Subject: MHI's Responses to US-APWR DCD RAI No. 354-2585 Revision 0

Responses to Request for Additional Information
No. 354-2585 Revision 0

**US-APWR Design Certification
Mitsubishi Heavy Industries, Ltd.
Docket No. 52-021**

RAI NO.: NO. 354-2585 REVISION 0
SRP SECTION: 06.02.02 – Containment Heat Removal System
APPLICATION SECTION: 6.2.2 & 6.3
DATE OF RAI ISSUE: 05/07/2009

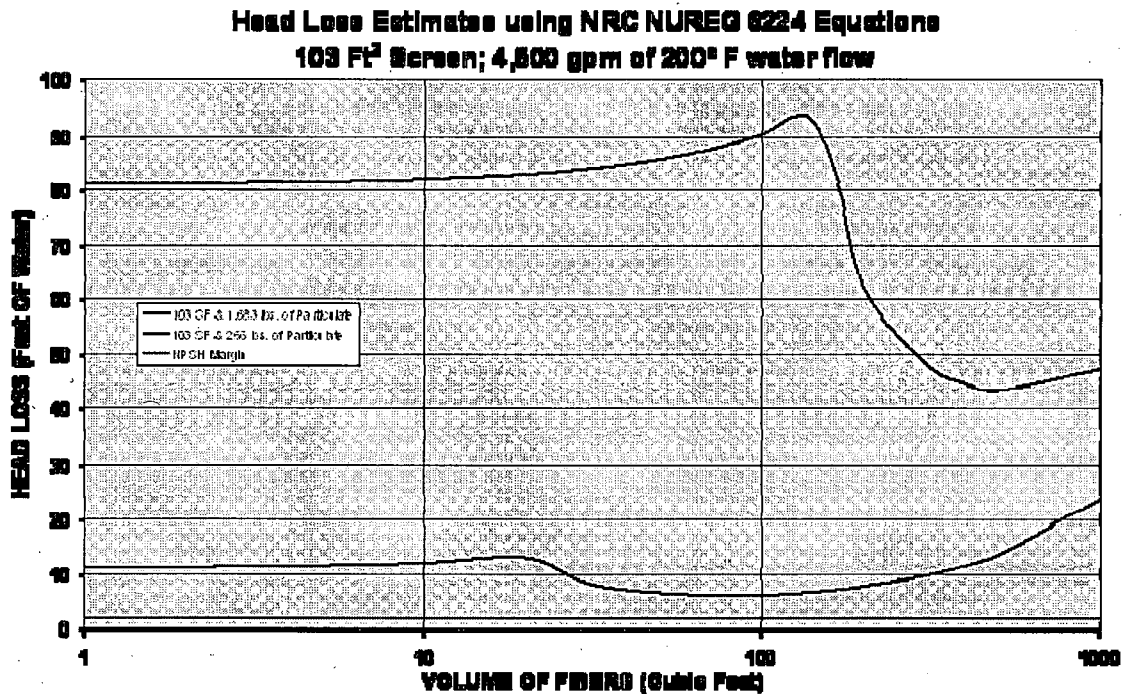
In MUAP 08001-NP (R2) Section 3.1, Break Selection, page 9, states, "For the USAPWR, PCI SFS has been selected. PCI has never observed any evidence of the thin bed effect in vendor's large flume testing facilities in the past, because of its three dimensional geometry and very low approach velocities. The TBE may occur only under such very controlled conditions where the fibrous debris is very carefully prepared as individual fibers that are slowly added to a closed vertical pipe loop test apparatus. This configuration is not applicable for the US-APWR strainer design and configuration in the RWSP of the post-LOCA conditions." This statement appears to be in conflict with recent operating plant testing experience during which high head loss (>20 feet) was achieved – indicative of a thin-bed effect - using a similarly designed PCI strainer. Therefore, the NRC staff requests MHI to address the ability of the screen to resist the formation of a thin bed or to accommodate partial thin bed formation.

The other plant case cited by the NRC is a high fiber design basis capable of engulfing the strainer if all fibrous debris predicted to reach the strainer actually did reach the screen in the test.

The statement, "PCI has never observed any evidence of the thin bed effect in vendor's large flume testing facilities in the past, because of its three dimensional geometry and very low approach velocities." is not saying their strainers have not formed a thin bed in a single test; nor is stating that high head losses do not occur from thin mixed fibrous / particulate debris beds on PCI strainers. The intention of the statement is that they have not observed the traditional NUREG CR/6224 head loss curve which plots the maximum head loss for different fiber debris quantities with a fixed quantity of particulates during a *single test*.

Figure 2.4.4-1 Emergency Core Cooling System (Sheet 4 of 4)

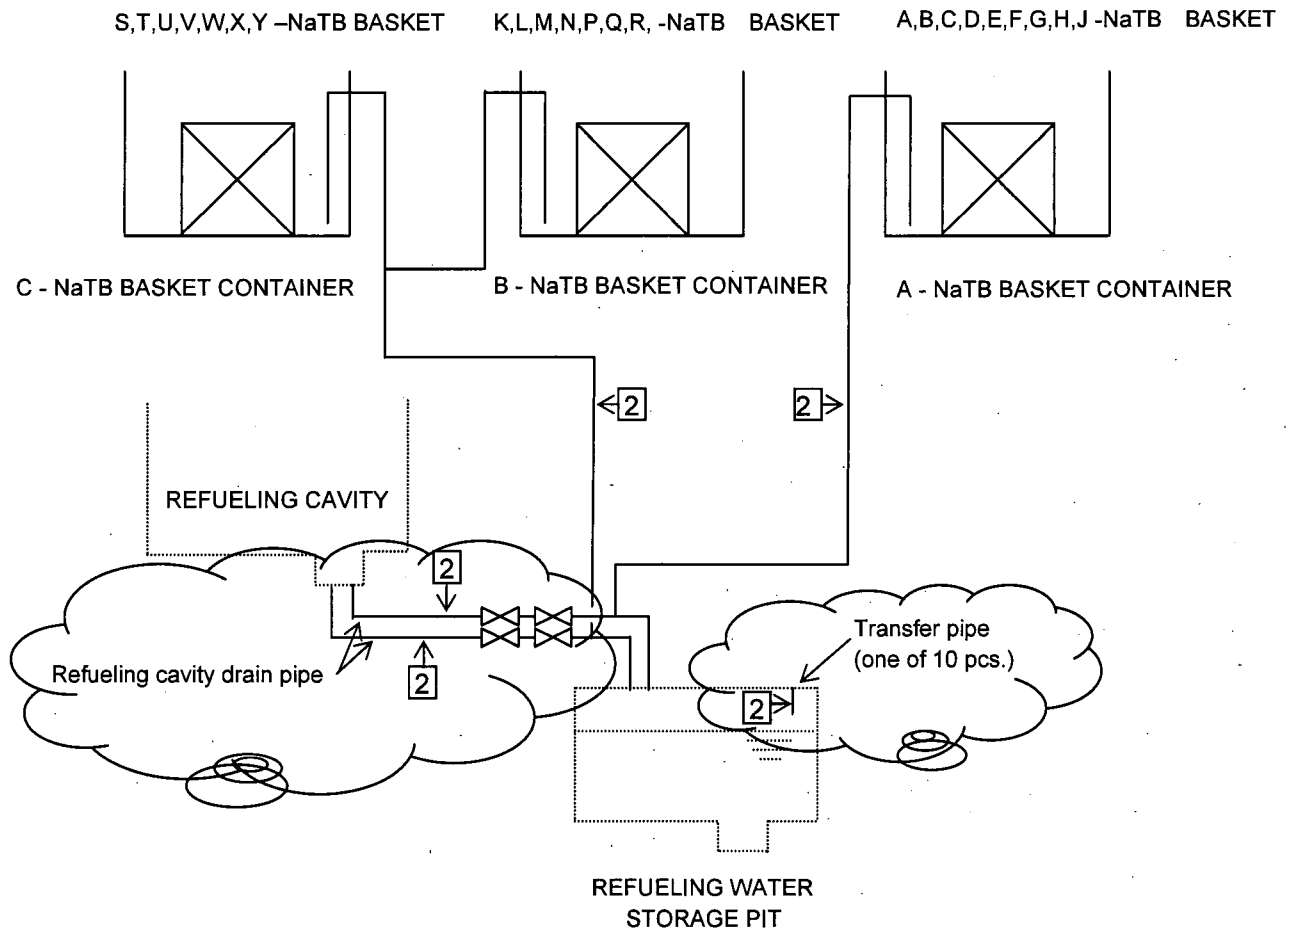
QUESTION NO.: 06.02.02-38

- Tier-1 Figure 2.4.4-1 "Emergency Core Cooling System (Sheet 4 of 4)" will be revised to add lines for transfer piping and refueling cavity drain piping.

- No additional inspection and acceptance criteria for the transfer piping and the refueling cavity drain piping are required beyond the current Tier-1 Table 2.4.4-5.
